# CFA Parham Issue Report - Apr 16, 2024

## #24 Kitchen Exhaust do not have hinge kit installed

M4.1

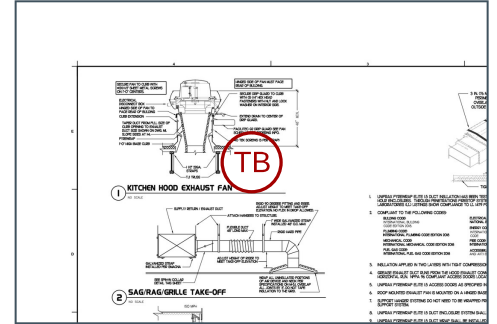
All kitchen exhaust fans are spec'd to have a hinge kit installed for all the fans.
